**ADDENDUM NO. 3
NEW PORTABLE CLASSROOMS FOR SPRINGVILLE ELEMENTARY SCHOOL
AND MARGARET ELEMENTARY SCHOOL
Architect Job No. 22-68
March 3, 2023
DCM # 2023043**

SPRINGVILLE ELEMENTARY
SCHOOL - ELECTRICAL

MARGARET ELEMENTARY
SCHOOL - ELECTRICAL

E2.1

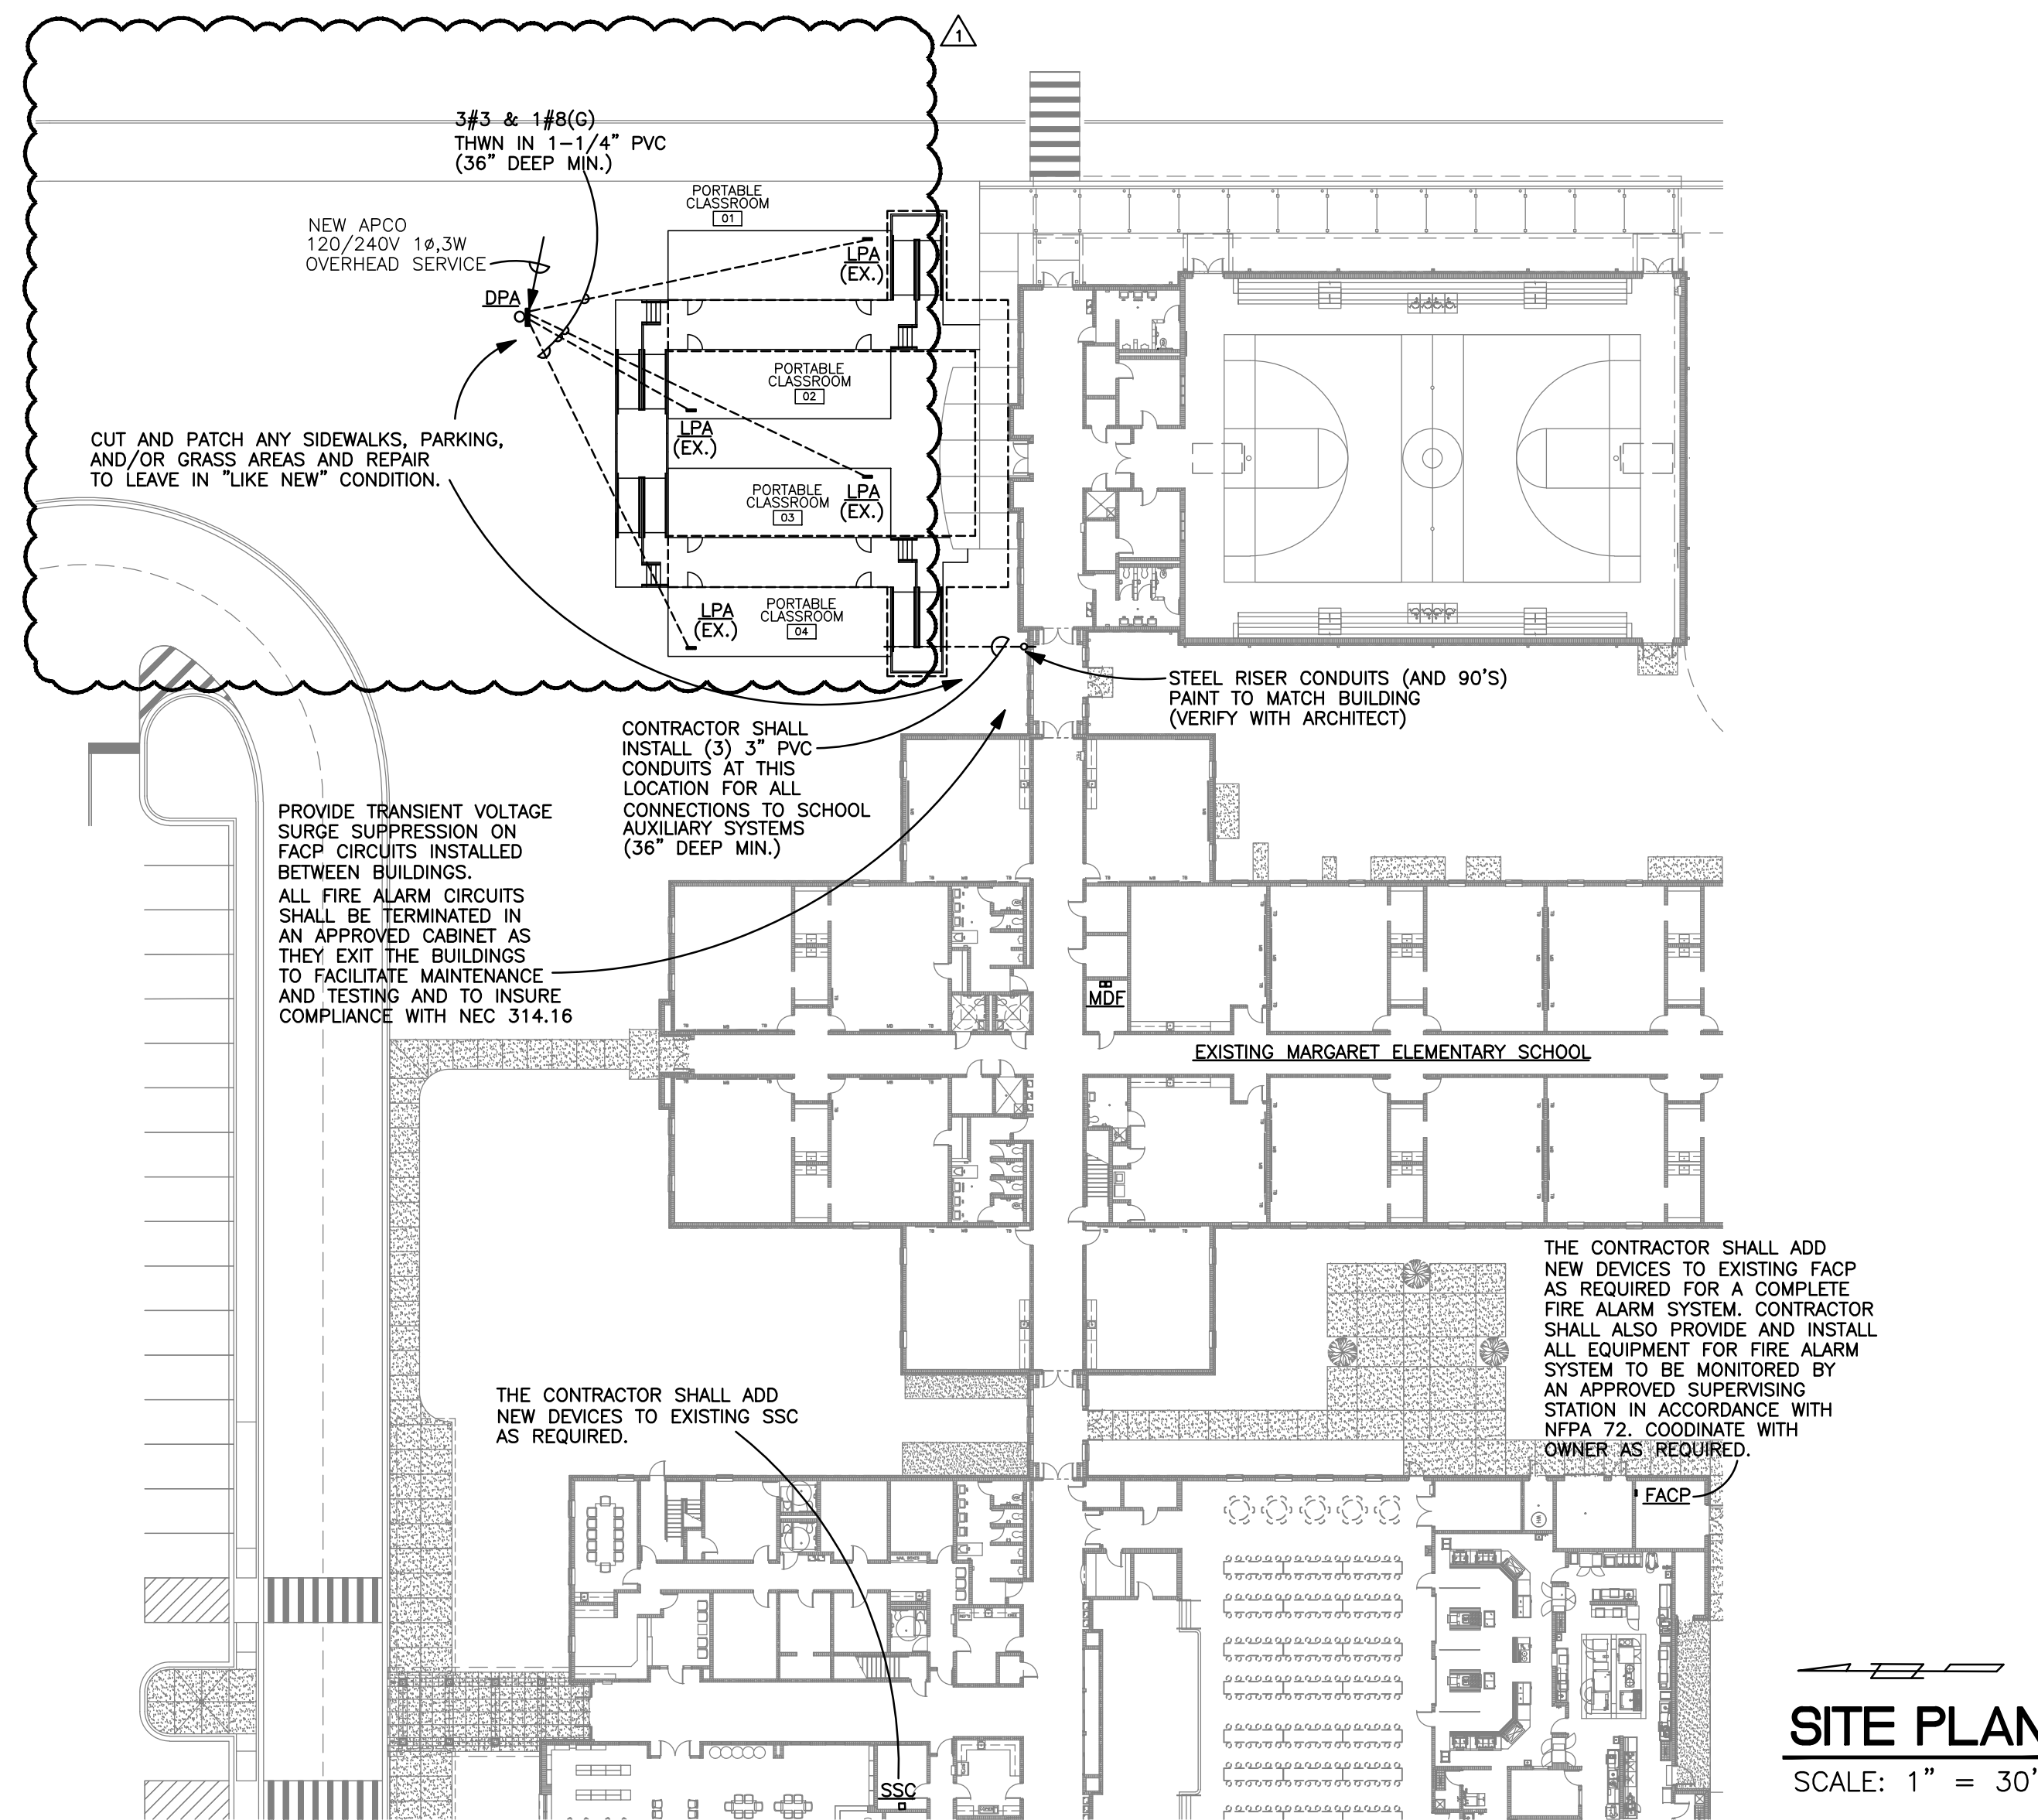
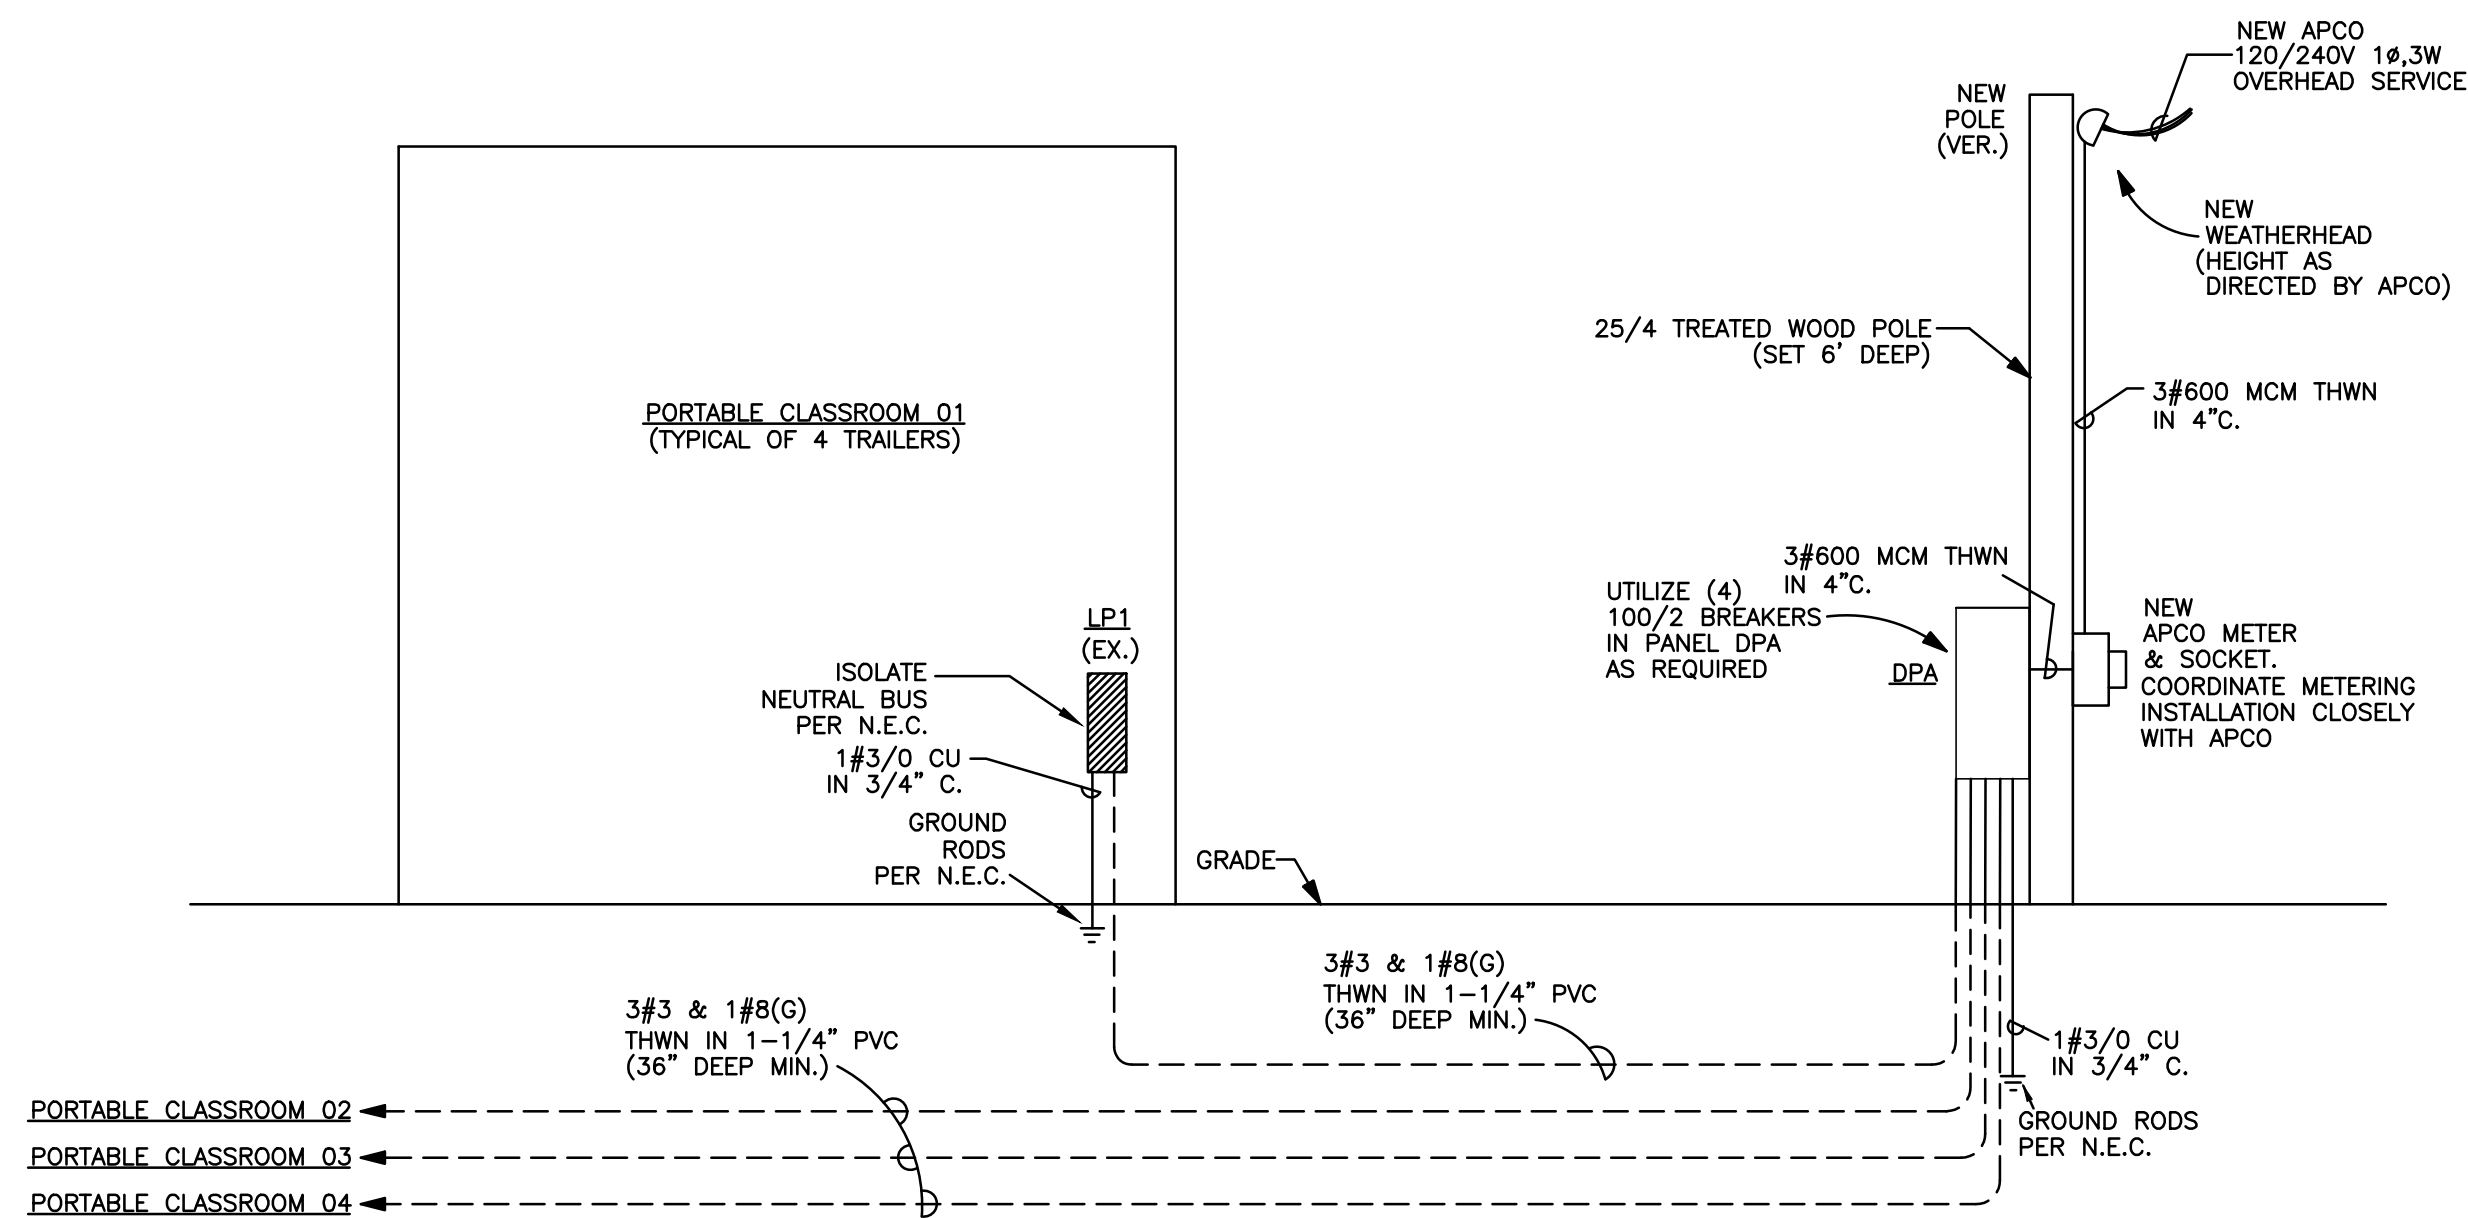
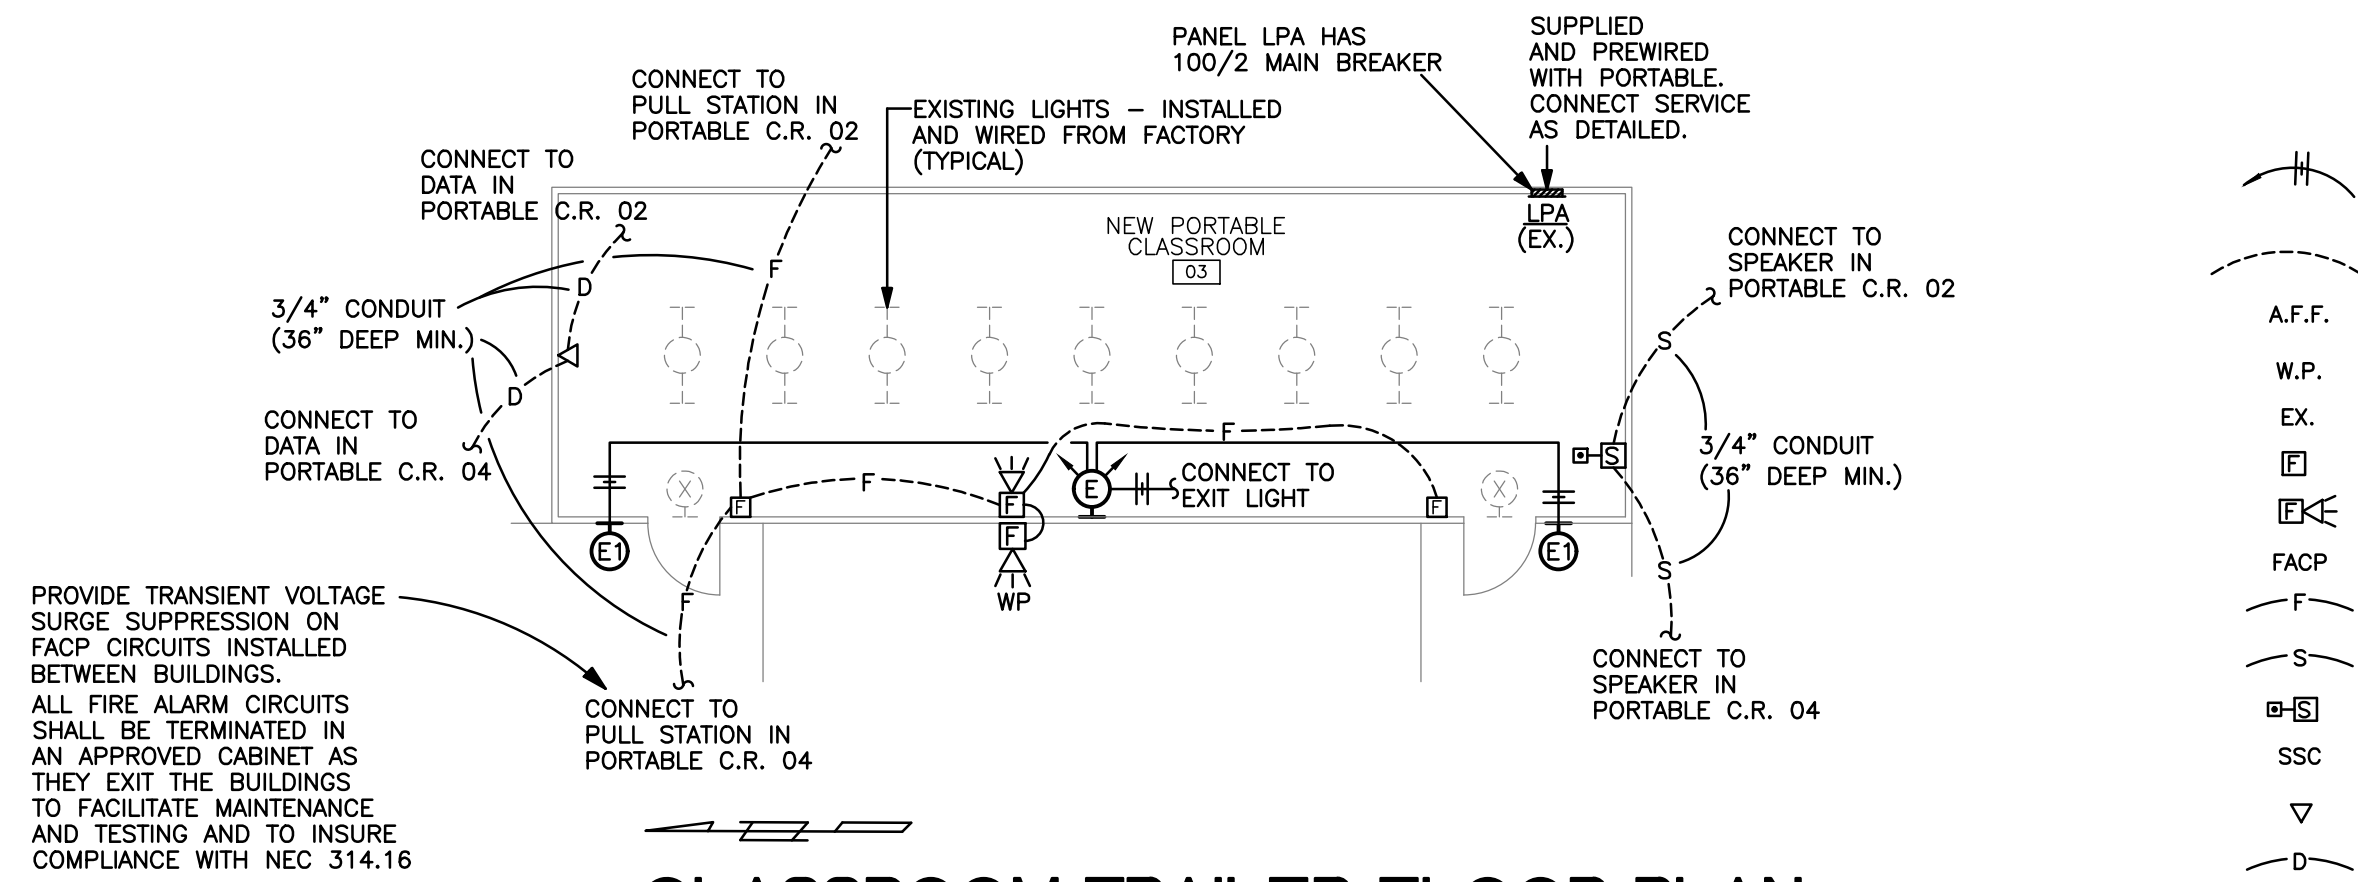
1. See attached **E1.1** for revisions.
2. See attached **E2.1** for revisions.
